FERC/FEIS-0082

# Lower Penobscot River Basin

**LICENSING THREE HYDROELECTRIC PROJECTS  
IN THE LOWER PENOBSCOT RIVER BASIN**

**Bangor Hydro-Electric Company**

Figure E-1. Schematic of ASAL model (FWS 1989).

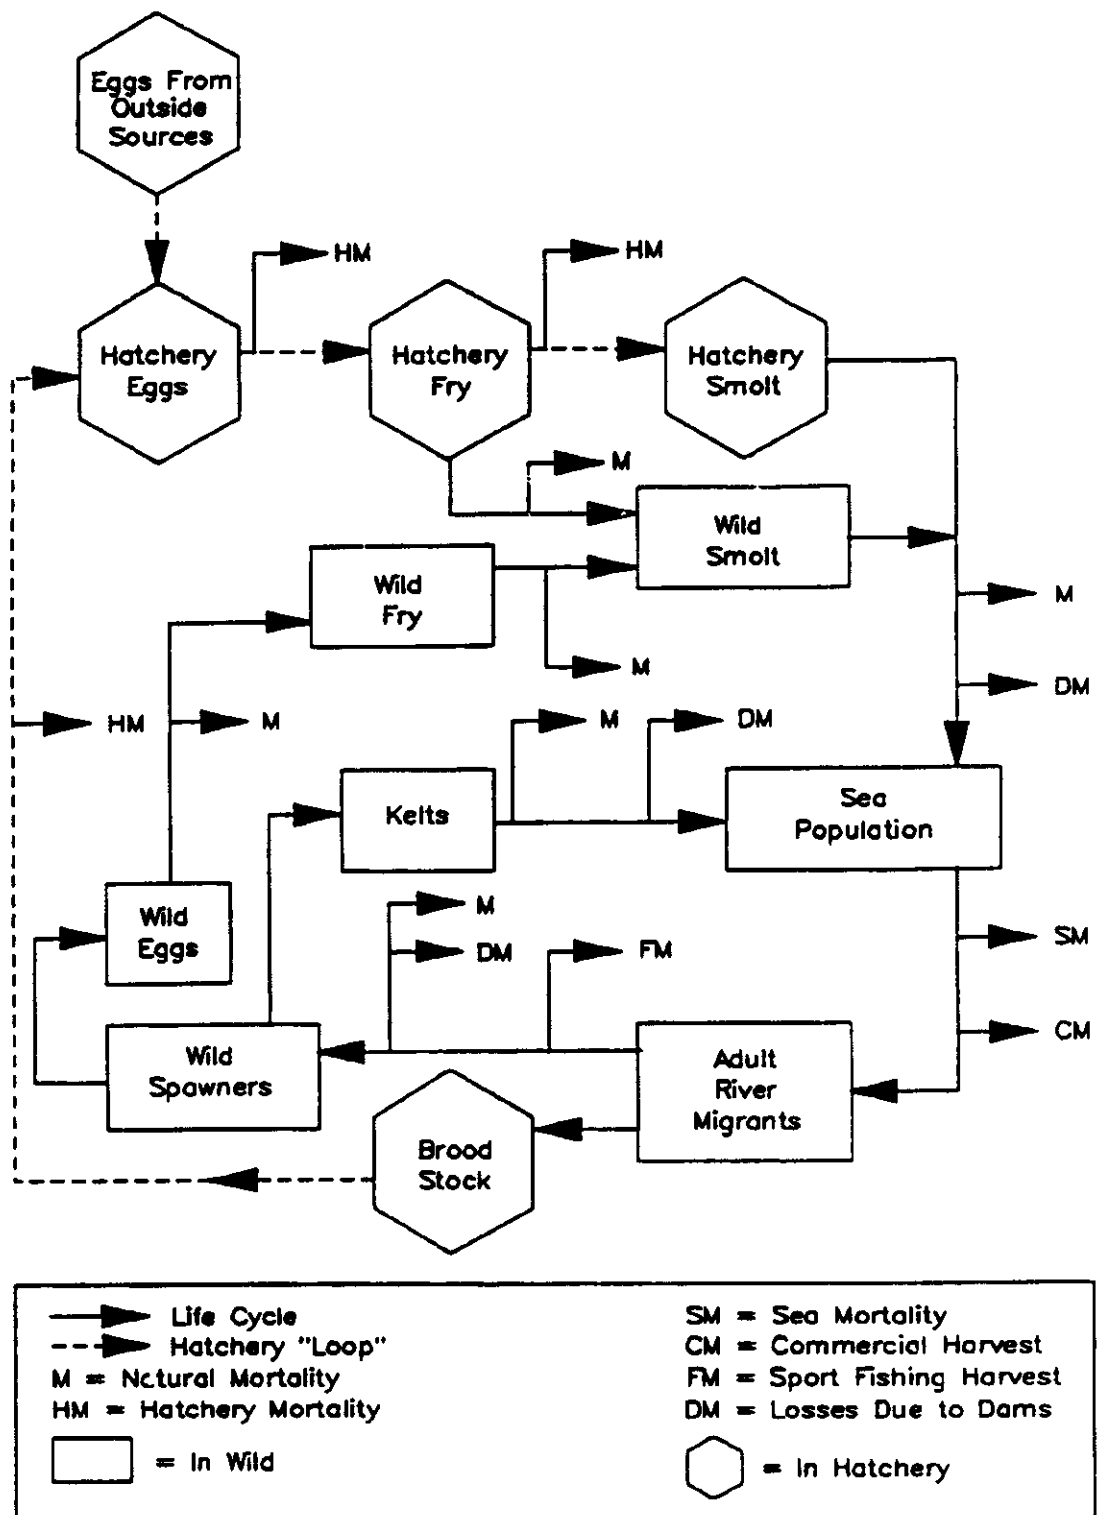
CI-27 FWS assumes that smolts resulting from stocked fry have the same marine survival as smolts resulting from natural spawning, supporting our position (see Figure E-1 in Appendix E). We recommend that any stocking mitigation that we would require of BHE under Alternative 3 be performed in the same manner as existing restoration efforts.

Figure F-4. Operating scenario 1.a observations of flow patterns (August 6, 1991). Plants A and B at a flow of 4,870 to 5,100 cfs with no flow at east side of Veazie Dam (Source: BHE 1992f).

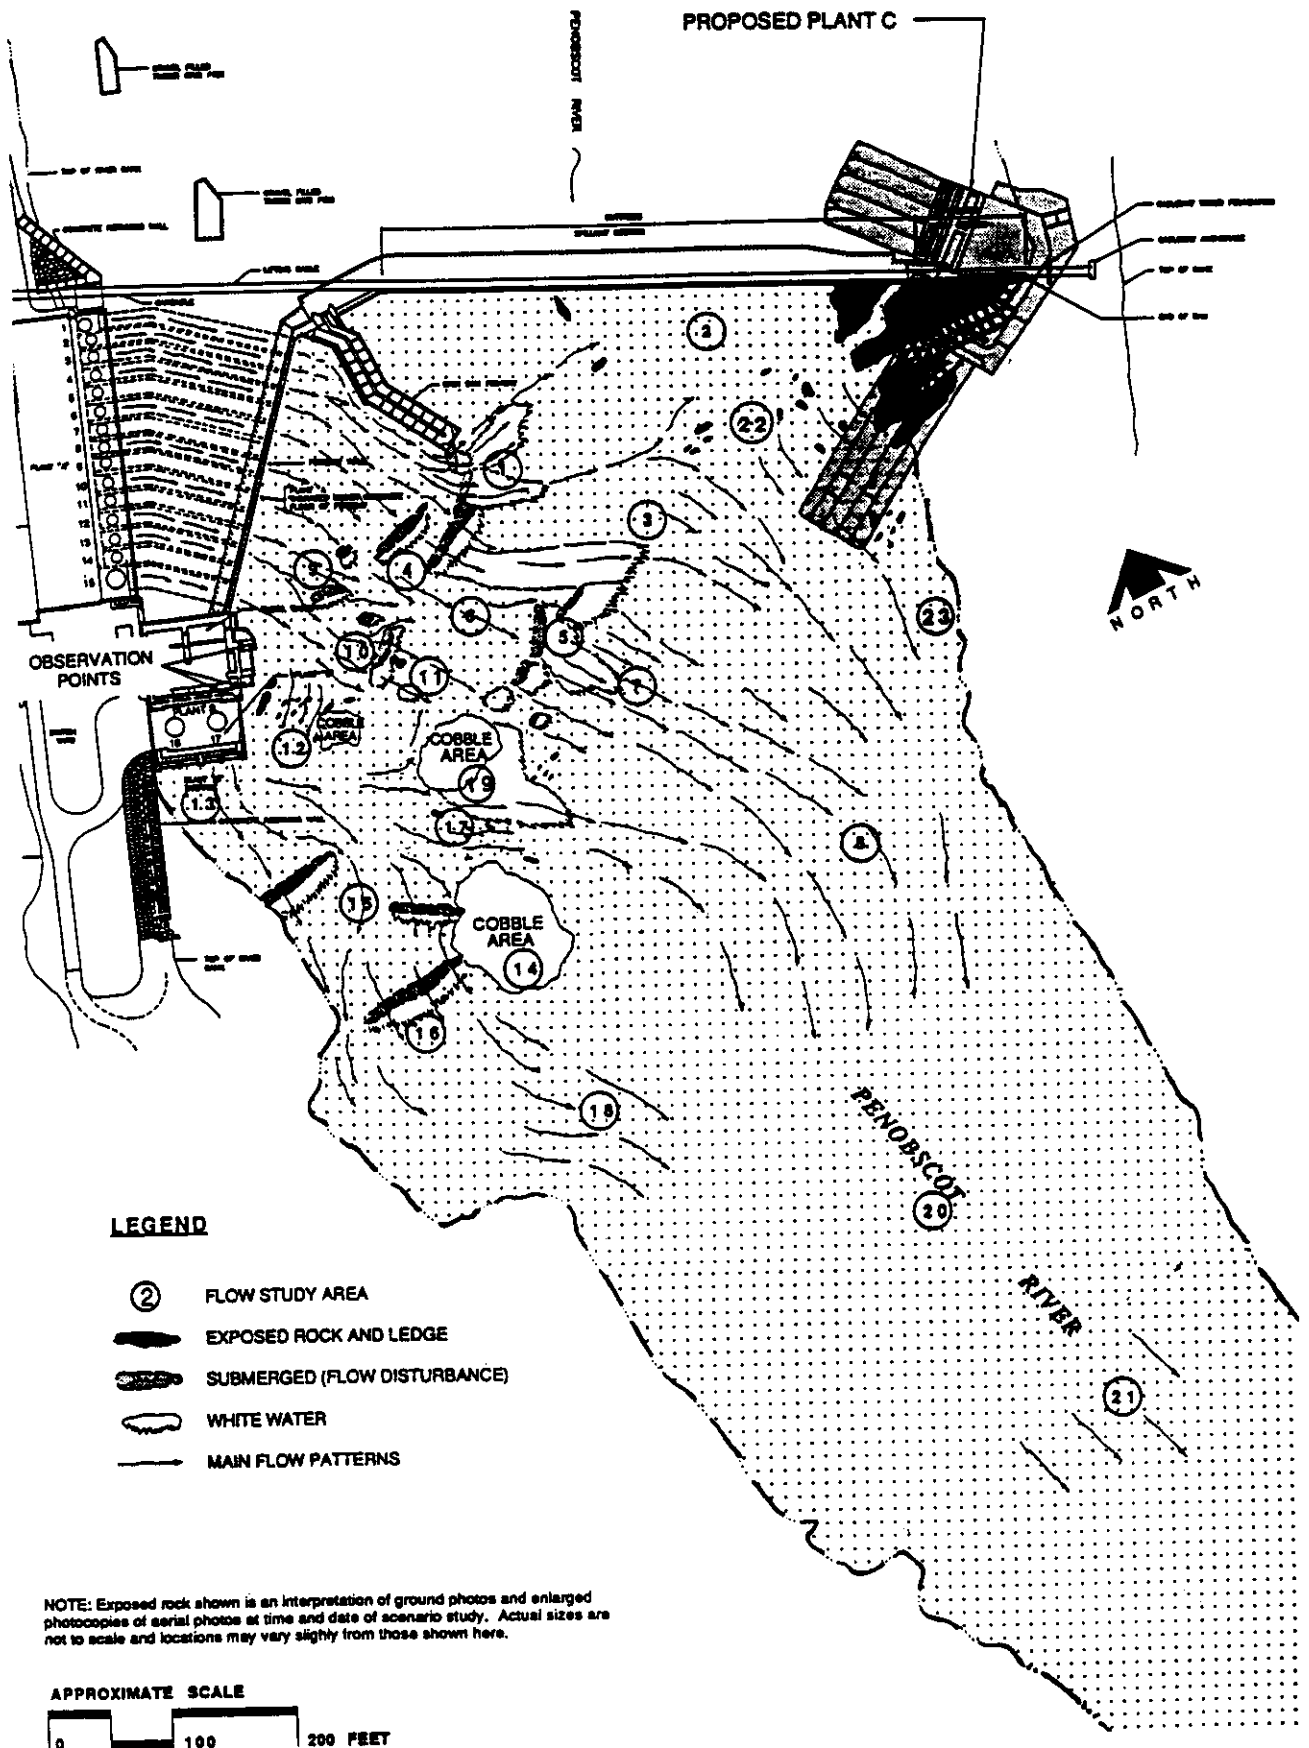
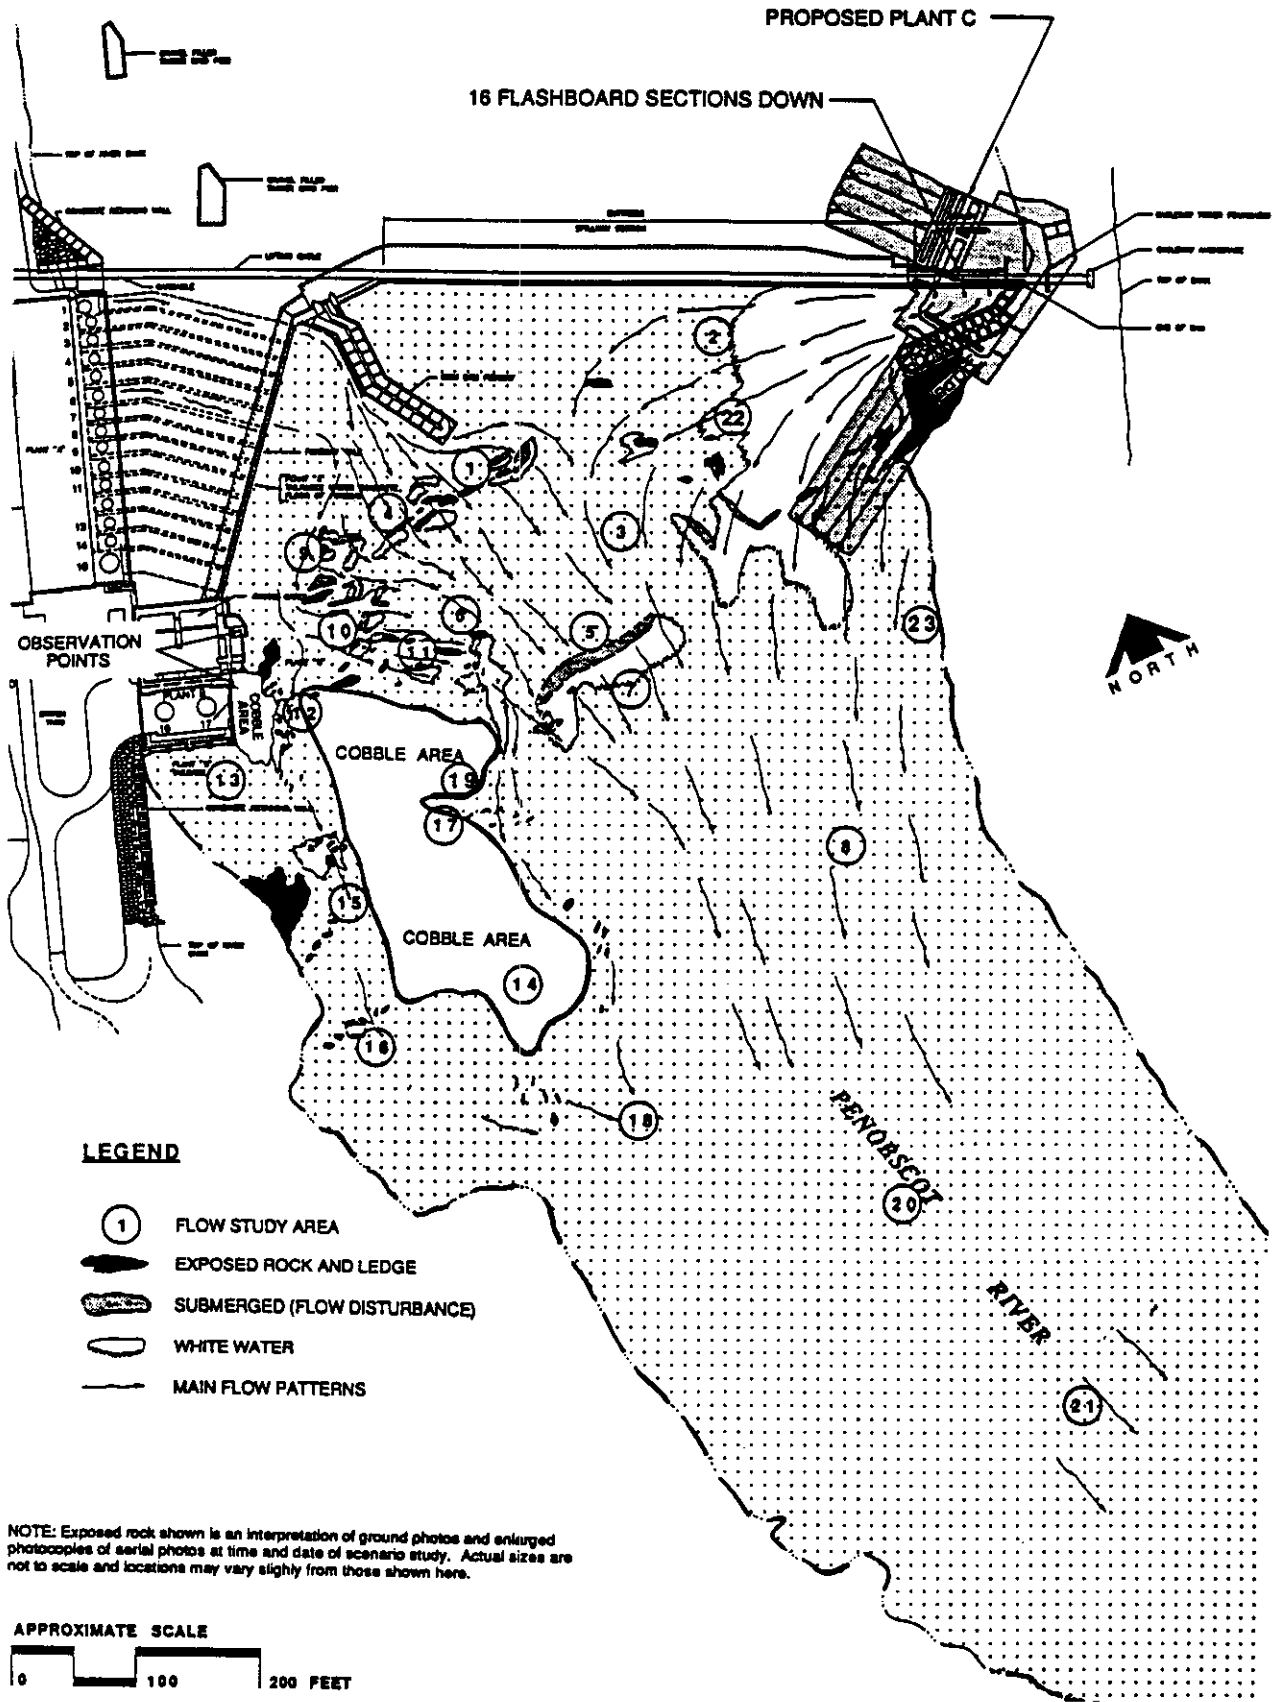
CI-42 The data we have reviewed (see Appendix F, e.g., Figures F-4 and F-5) lead us to conclude that impacts would not be as great as Mr. Westfall contends. Also, as we have indicated in the FEIS (Appendix F), there is an inherent conflict between plant operations that would facilitate upstream passage efficiency and operations that would enhance recreational fishing (or reduce plant impact on fishing opportunity) below Veazie. Our position is that improved upstream passage efficiency is of greater importance than improved recreational fishing because of the positive benefits to population growth. You provide no new data or information on this issue, and we thus have no basis for altering our conclusion.
